# UNITED STATES PATENT AND TRADEMARK OFFICE

APPLICATION NO.	FILING DATE	FIRST NAMED INVENTOR	ATTORNEY DOCKET NO.	CONFIRMATION NO.
10/587,581	09/11/2006	Anatoli Stobbe	STOBBE-19 PCT	9668
25889	7590	10/02/2009	EXAMINER	
COLLARD & ROE, P.C. 1077 NORTHERN BOULEVARD ROSLYN, NY 11576			HURLEY, SHAUN R	
			ART UNIT	PAPER NUMBER
			3765	
			MAIL DATE	DELIVERY MODE
			10/02/2009	PAPER

<b>Office Action Summary</b>	<b>Application No.</b> 10/587,581	<b>Applicant(s)</b> STOBBE, ANATOLI	
	<b>Examiner</b> Shaun R. Hurley	<b>Art Unit</b> 3765

## **DETAILED ACTION**

**Fig. 4**

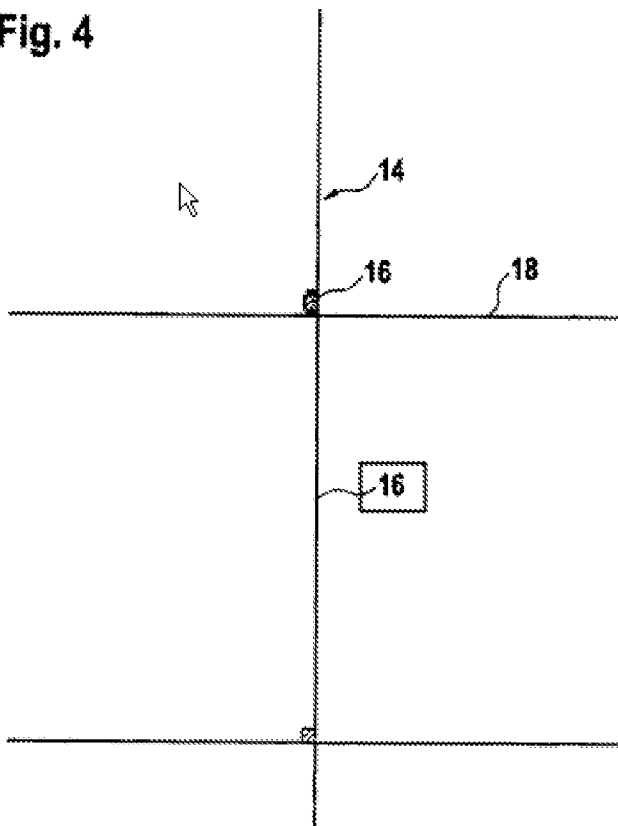
Detail 16 in Figure 4 is incorrect:

Corrected drawing sheets in compliance with 37 CFR 1.121(d) are required in reply to the Office action to avoid abandonment of the application. Any amended replacement drawing sheet should include all of the figures appearing on the immediate prior version of the sheet, even if only one figure is being amended. The figure or figure number of an amended drawing should not be labeled as “amended.” If a drawing figure is to be canceled, the appropriate figure must be removed from the replacement sheet, and where necessary, the remaining figures must be renumbered and appropriate changes made to the brief description of the several views of the drawings for consistency. Additional replacement sheets may be necessary to show the renumbering of the remaining figures. Each drawing sheet submitted after the filing date of an application must be labeled in the top margin as either “Replacement Sheet” or “New Sheet” pursuant to 37 CFR 1.121(d). If the changes are not accepted by the examiner, the applicant will be notified and informed of any required corrective action in the next Office action. The objection to the drawings will not be held in abeyance.
